CEN/TC 98/WG 3 N0001

Template for comments and secretariat observations

Date: 2015-10-19	Document: EN 1493:2010	Project: Revision
------------------	------------------------	-------------------

Stopping forces runway lifts				a	b	c	d	e	f

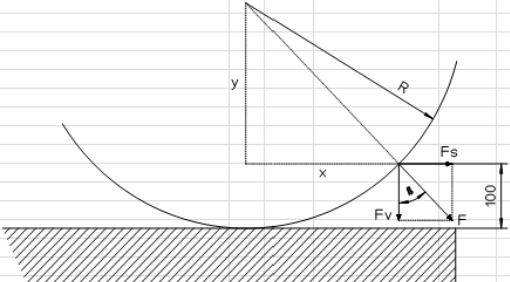
No.	MB/ NC ¹	Clause/ Subclause (e.g. 3.1)	Paragraph/ Figure/ Table/ (e.g. Table 1)	Type of comment ²	Comments	Proposed change	Observations of the secretariat
					<p>through l, because in most cases they just fit on a lift. Furthermore these vehicles have different wheel sizes, which give different angles at which the radial force is working. In the new calculations, also the rolling resistance is included, the stopping time is reduced from 1 second to the 0,8 second that Maha used in their calculation. This all results in total horizontal stopping forces from 8% to max 16% of rated capacity. Also a check is done on the height of the end stop: it should prevent the vehicle from driving over it. This is proven by the vertical resultant force that has to be smaller than the smallest axle load.</p> <p>3) The expression 'horizontal force' needs to be changed. Since this horizontal force is a <i>resultant</i> of the radial force, it never works without the, also resultant, vertical force (see calculation in Excel file). When designing end stops, these forces are taken into account. Therefore the wording that is used to describe the load on the end stop should be changed as well.</p>
